HIGHWAY WORK PROPOSAL

Proposal Number: **012**

<u>COUNTY</u>	<u>STATE PROJECT</u>	<u>FEDERAL</u>	<u>PROJECT DESCRIPTION</u>	<u>HIGHWAY</u>
Columbia	6217-00-78	N/A	Town Of Columbus, Old Sth 73 Rd; Crawfish River Bridge, B-11-0175	LOC STR

QUANTITIES,
 TYPICAL SECTION
 & NOTES
 SHEET 2 OF 26
40

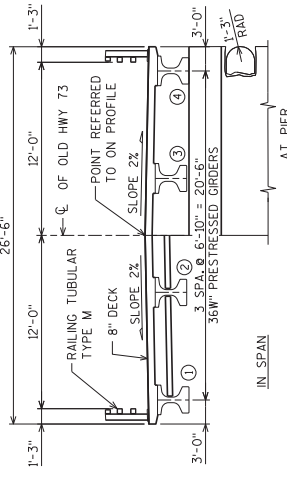
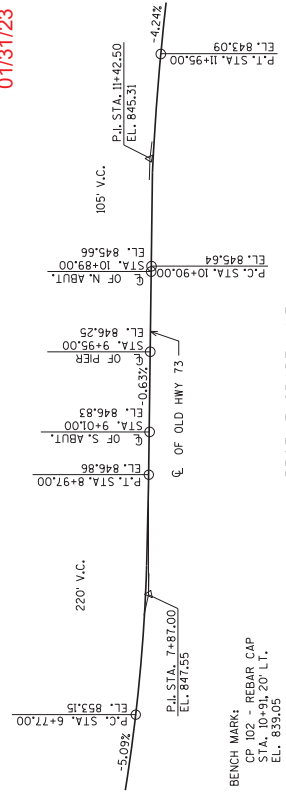
Revised Plan Sheets	
Plan Sheet	Plan Sheet Title (brief description of changes to sheet)
40	Quantities (switched N. Abutment and Pier quantities)

BID ITEM NUMBER	BID ITEMS	UNIT	S. ABUT.	PIER	N. ABUT.	SUPER.	TOTAL
203.0250	REMOVING STRUCTURE OVER WATERWAY REMOVE DEBRIS B-11-910	EACH	-----	-----	-----	-----	1
